PIC24FJ64GB004 Family Silicon Errata and Data Sheet Clarification

The PIC24FJ64GB004 family devices that you have received conform functionally to the current Device Data Sheet (DS39940D), except for the anomalies described in this document.

Data Sheet Clarifications

The following typographic corrections and clarifications are to be noted for the latest version of the Device Data Sheet (DS39940D):

FIGURE 2-3 FREQUENCY vs. ESR PERFORMANCE FOR SUGGESTED VCAP

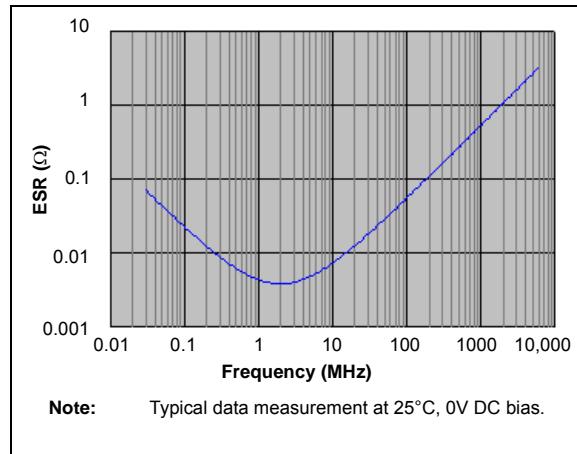
Section 2.4 Voltage Regulator Pins (ENVREG/DISVREG and VCAP/VDDCORE) has been replaced with a new and more detailed section. The entire text follows:

When the regulator is enabled, a low-ESR ($< 5\Omega$) capacitor is required on the VCAP/VDDCORE pin to stabilize the voltage regulator output voltage. The VCAP/VDDCORE pin must not be connected to VDD and must use a capacitor of 10 μF connected to ground. The type can be ceramic or tantalum. Suitable examples of capacitors are shown in [Table 2-1](#). Capacitors with equivalent specifications can be used.

Designers may use [Figure 2-3](#) to evaluate ESR equivalence of candidate devices.

FIGURE 2-4 DC BIAS VOLTAGE vs. CAPACITANCE CHARACTERISTICS

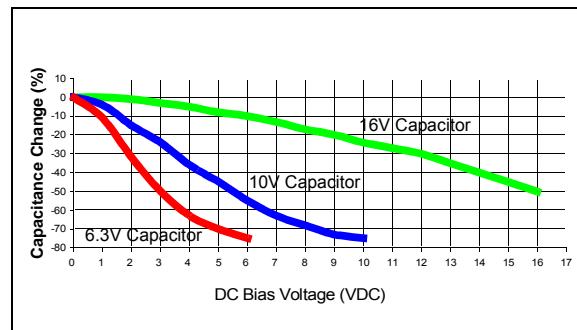
A typical DC bias voltage vs. capacitance graph for 16V, 10V and 6.3V rated capacitors is shown in [Figure 2-4](#).

When selecting a ceramic capacitor to be used with the internal voltage regulator, it is suggested to select a high-voltage rating, so that the operating voltage is a small percentage of the maximum rated capacitor voltage. For example, choose a ceramic capacitor rated at 16V for the 2.5V core voltage. Suggested capacitors are shown in [Table 2-1](#).

FIGURE 29-1: PIC24FJ64GB004 VOLTAGE-FREQUENCY GRAPH (INDUSTRIAL)

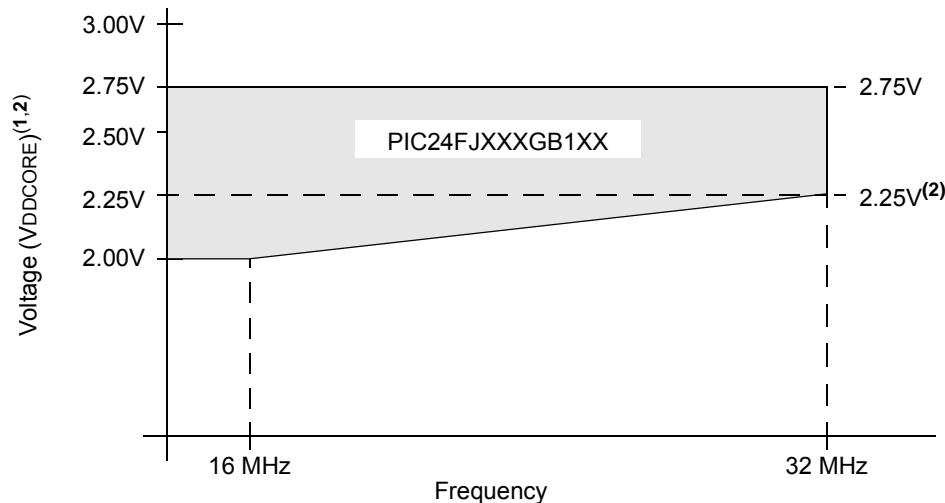
[Figure 29-1 \(“PIC24FJ256GB110 Family Voltage-Frequency Graph”\)](#) is amended by adding an additional footnote. The updated figure is shown below (changes in **bold**; bold in original removed for clarity).

For frequencies between 16 MHz and 32 MHz, $F_{MAX} = (64 \text{ MHz}/V) * (VDDCORE - 2\text{V}) + 16 \text{ MHz}$.

- Note 1:** When the voltage regulator is disabled, VDD and VDDCORE must be maintained so that $VDDCORE \leq VDD \leq 3.6\text{V}$.
- 2:** When the USB module is enabled, VUSB should be provided at 3.0V to 3.6V, while VDDCORE must be 2.35V. When the USB module is not enabled, the wider limits shaded in grey apply. The voltage on the VUSB pin should be maintained at $(VDDCORE - 0.3\text{V})$ or greater; optionally, the pin may be left in a high-impedance state when the USB module is not in use, but doing so may result in higher IPD currents than specified.

28-Lead Plastic Small Outline (SO) - Wide, 7.50 mm Body [SOIC]

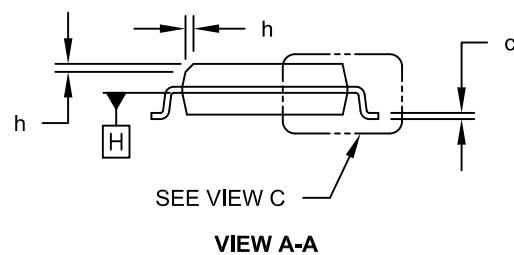
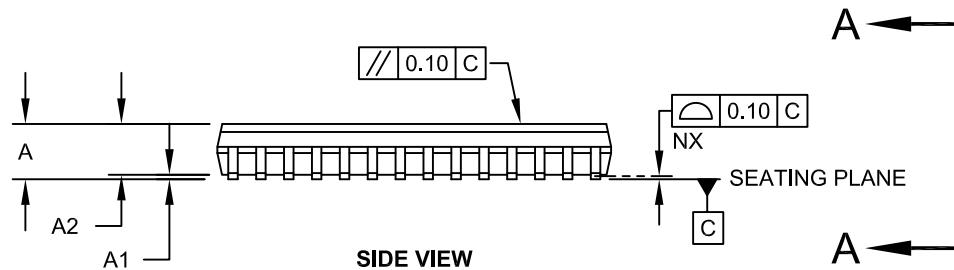
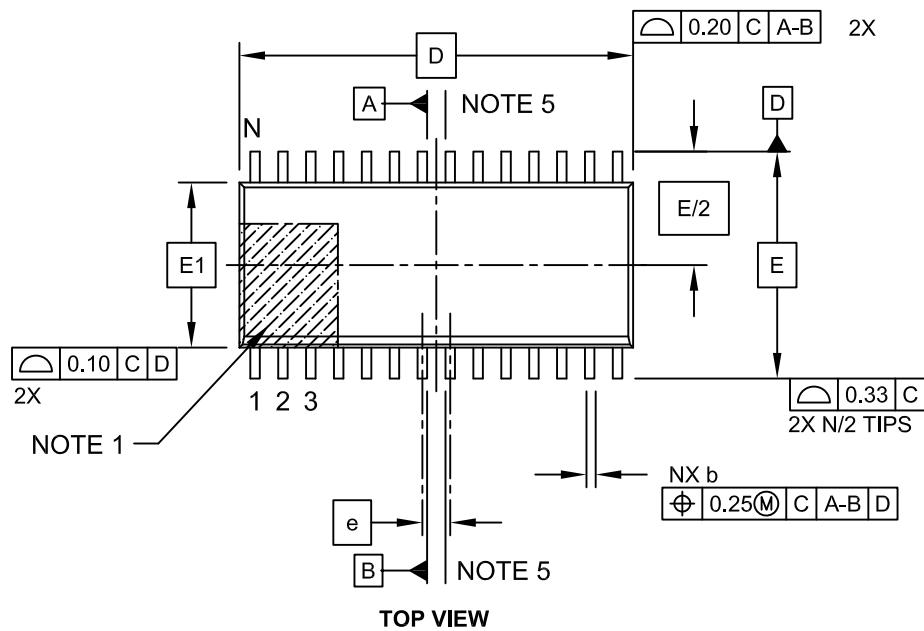
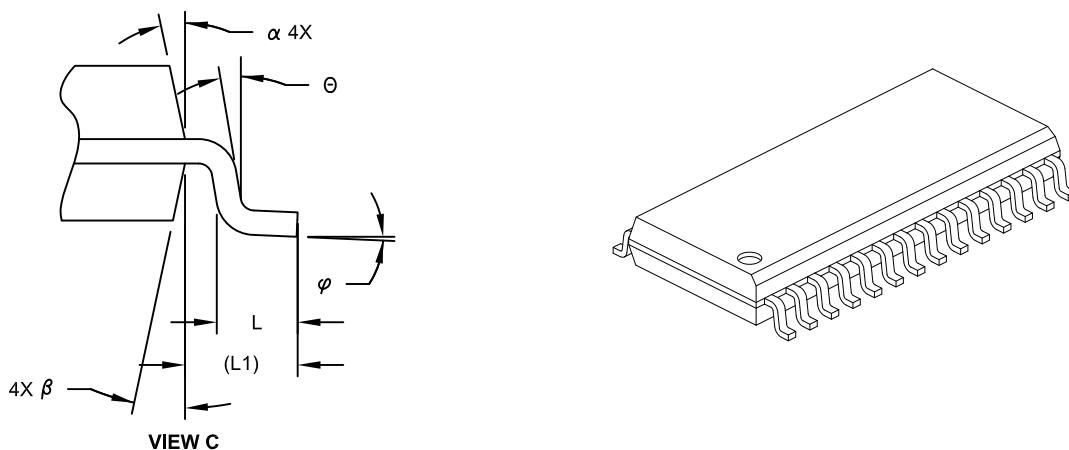
Section 30.0 “Packaging Information” omits the drawings for 28-pin SOIC packages (7.5 mm, type SO), which are a valid packaging option for this device family. The applicable Microchip drawings (C04-052C, two sheets, and C04-2052A) are added to the section. They appear on the following pages.
